TOWN OF SMITHFIELD BOARD OF ADJUSTMENT AGENDA PACKET

Meeting Date: Thursday, February 23, 2023

Subject: 1109 N Brightleaf Blvd Variance
Department: Planning
Presented by: Mark Helmer, Senior Planner
Presentation: Yes

Agenda Item: BA-23-02
Date: 2/23/23

proposed
VARIANCE request

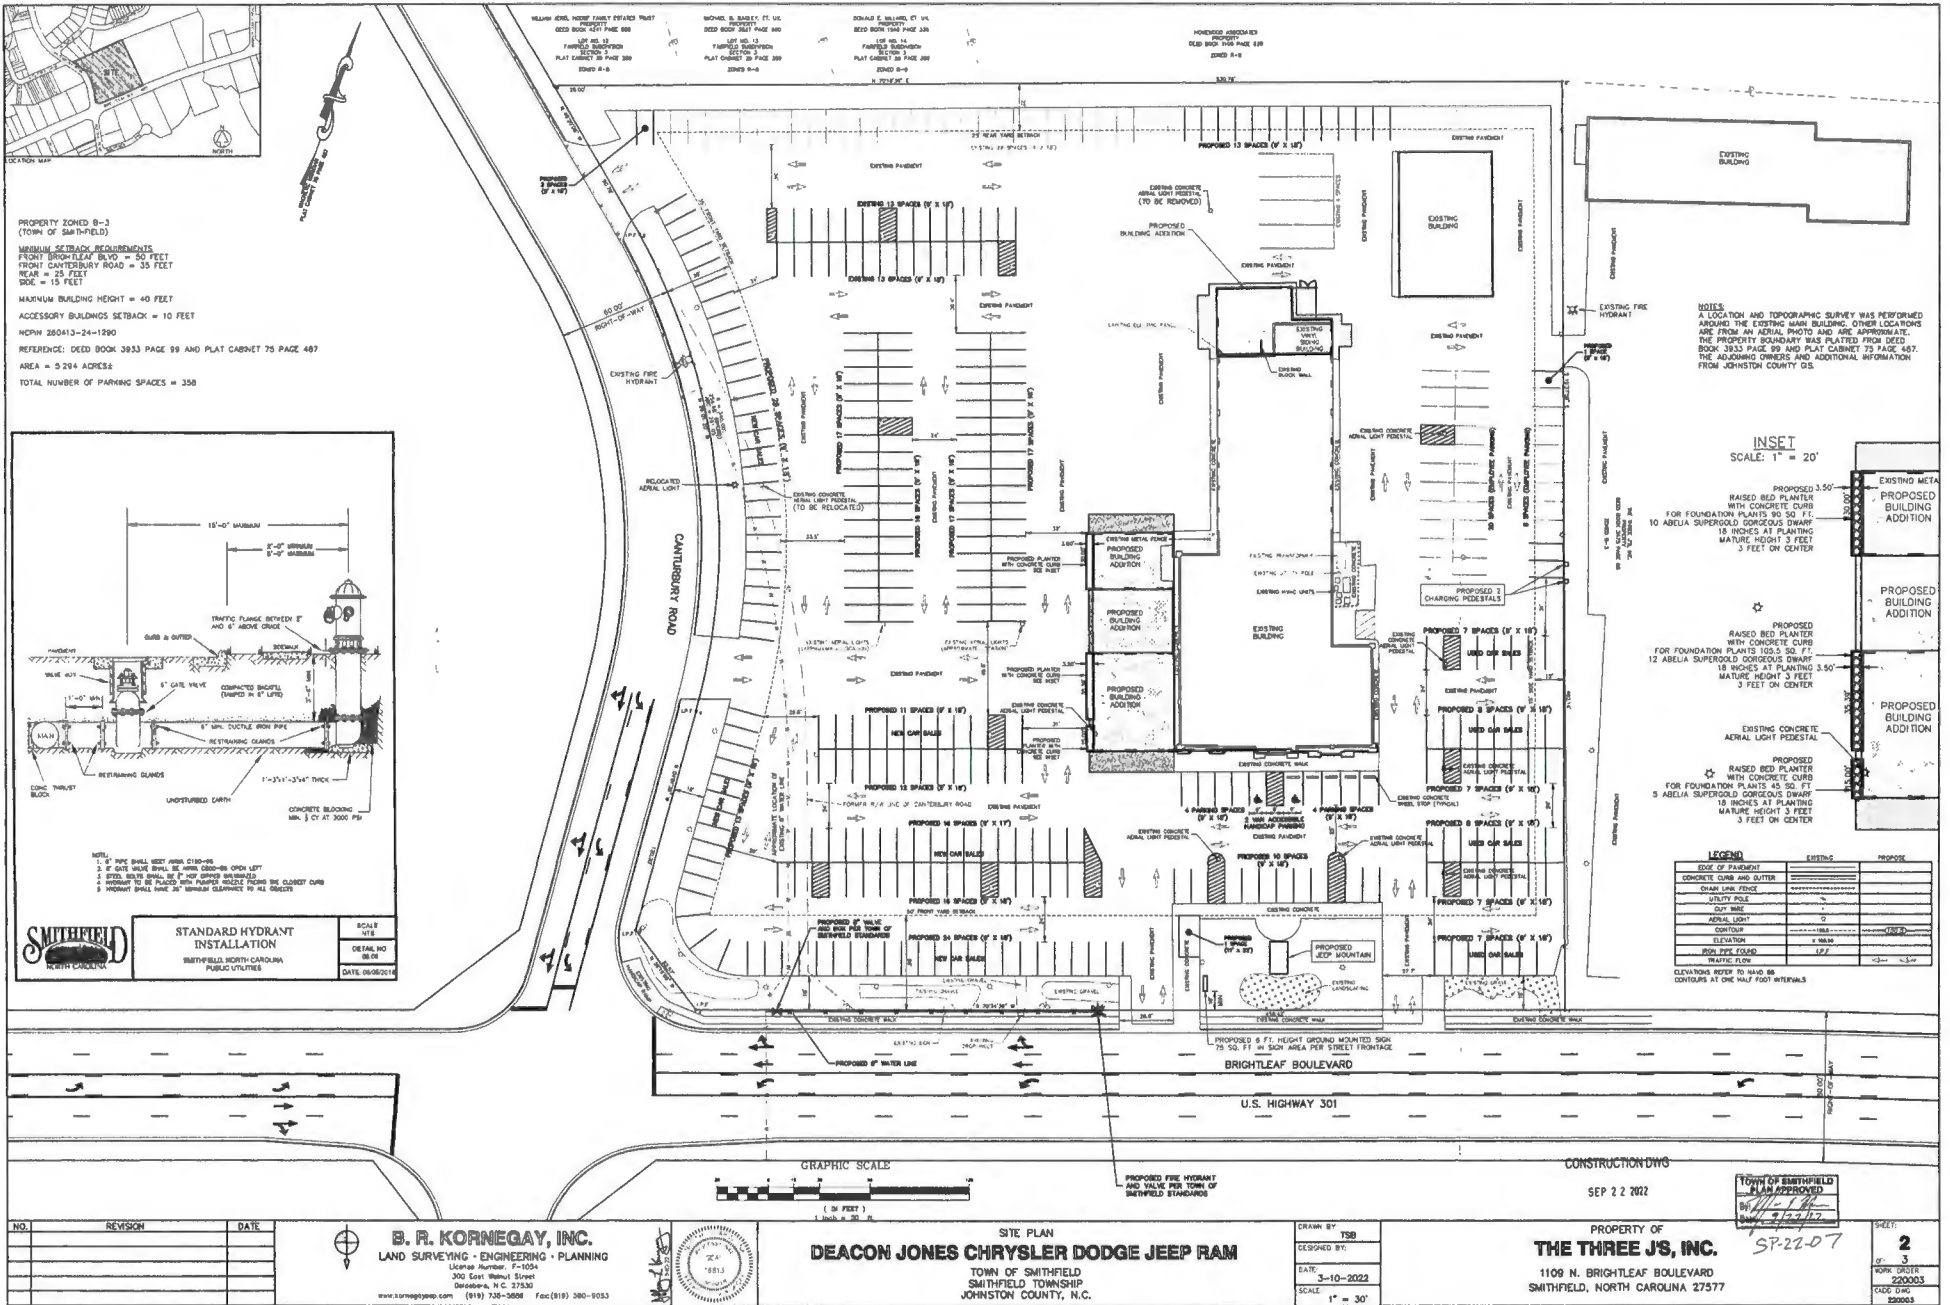
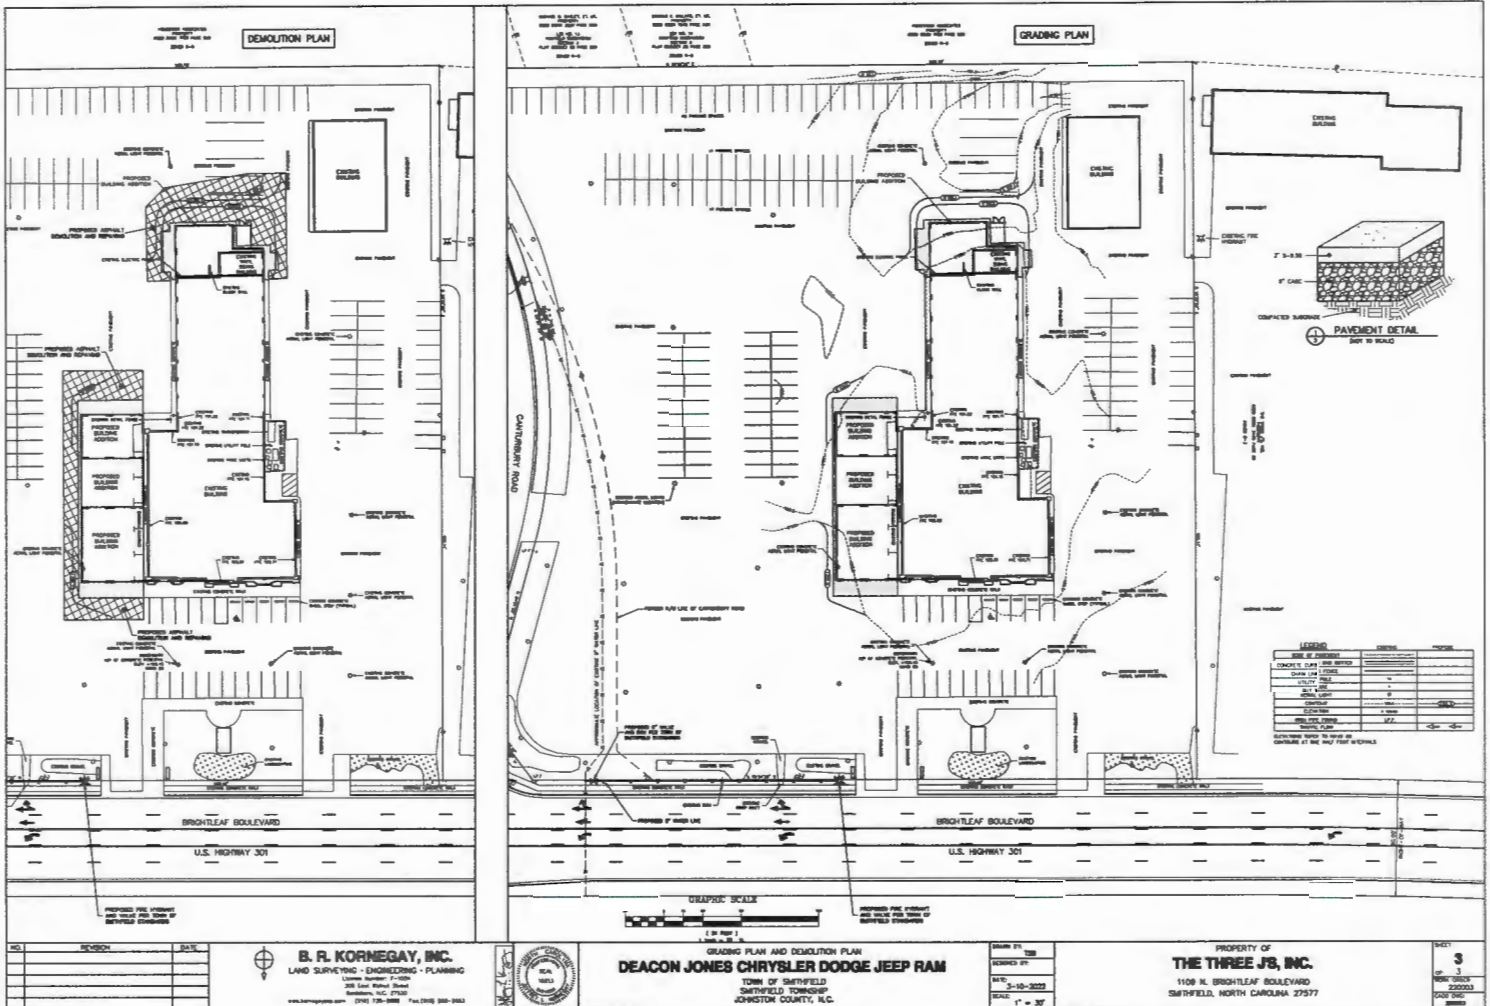
The applicant is expanding its operations and building footprint to add a new car brand. The building expansion is on the west side of the building affecting existing parking lot area. The town's UDO requires parking lot striping with a zoning permit for the project. The applicant is requesting a variance from the parking lot striping requirement. The applicant would like to park and display cars as it has for years without parking lot striping.

The UDO Section 10.2.5.2 by itself does not provide specificity as to how the marking should be provided. The Town's Standard Details and Specifications provides the Town standard:

... All minimum stall depths and module widths shall be measured to the face of curb when curb and gutter is used. All paved parking facilities shall be striped in accordance with the MUTCD with four (4) inch white lines.

7.44.1. All vehicles for stored outside for display, or sale shall be on a paved surface of bituminous, concrete or other approved comparable surface and in a striped parking stall complying with Article 10, Part I, or stored within a paved storage yard screened from the public right-a-way by a durable opaque fence, opaque wall and/or a solid vegetative buffer with a minimum height of six (6) feet.

Planning Staff recommends the Board of Adjustment deny the variance request, BA-23-02, based on the finding of fact.
